QUALITY ASSURANCE -- NON-CONFORMANCE REPORT

Report No: NCR-000531

NCR #: ZPMC-0504

Reference Description: Segment 5CW Heat Straightening in wet conditions and not following the approved HSR

简图 Sketch

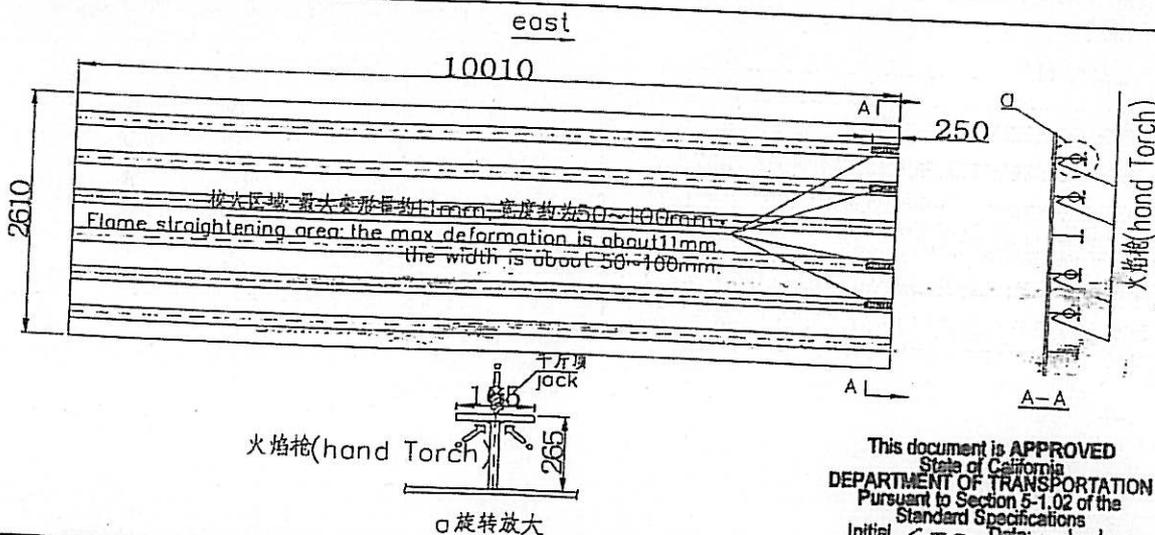
缺陷去除方(Defect Removal Method): Using hand torch and additional force (Jack) as well 使用火焰枪以及外力(千斤顶)进行校火

Jacking shall not be used to plastically deform the edge plate. The jack shall only be used as a fixture. After finishing the heat straightening operation, VT, MT and UT shall be performed on the entire length of the weld between the SPCM floor beam and edge plate stiffener. 不能使用千斤顶进行塑性变形, 千斤顶只能用作固定装置, 校火后需按照图纸上的要求对SPCM隔板与翼缘板之间焊缝进行VT, MT和UT检测。
